**Re: PA22-024- Marysville 44th PRD – Technical Review 1
7315 / 7417 44th St NE – APN(s) 30053500303700 / 30053500303600**

This letter is provided as response to comments dated August 17, 2022. Each item has been carefully reviewed and considered and the following is a summary of how each item was addressed.

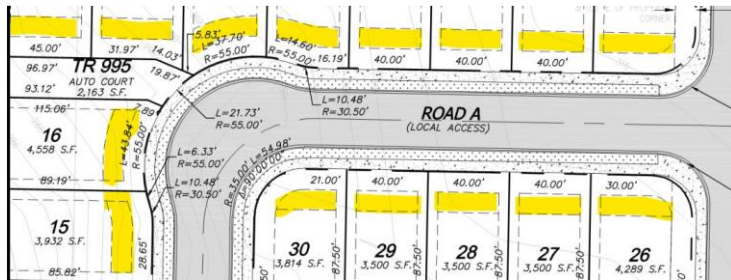
5. Please provide clarification as to what the roughly 300 sq. ft. highlights areas are below:

The two lines represent the 10' Front street setback and the back line is the setback to face of garage, 10 and 20 feet respectively.
